Our Case Number: ABP-317767-23

Re: Proposed construction of 39 residential units, widening of Pausdeen Bridge and all associated site works.
Newtown/Ardclough Road, Newtown, Celbridge, Co. Kildare.

Planning Observation Submissions to An Bord Pleanála

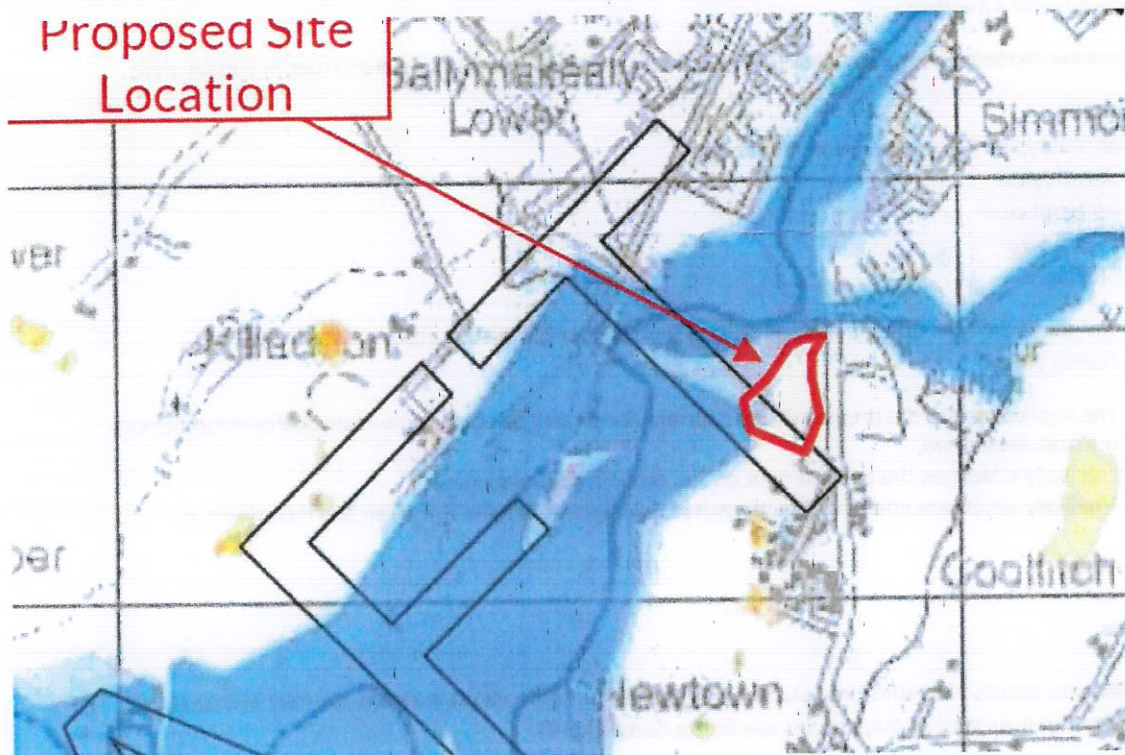
Very little tolerance: The predicted high water level of the site at O9LIFF02820 and 0.1% AEP is 52.95m. However evidence shows water further into the site. The Topographical survey indicates a Northwestern Fall

with levels varying from 53.80 to 53.0m OD at the Northwestern Edge. Are we to assume therefore that it was the illegal dumping which has helped to raise the site? Also 5cm clearance from a map without empirical current site data is hardly reassuring as good tolerance to flooding.
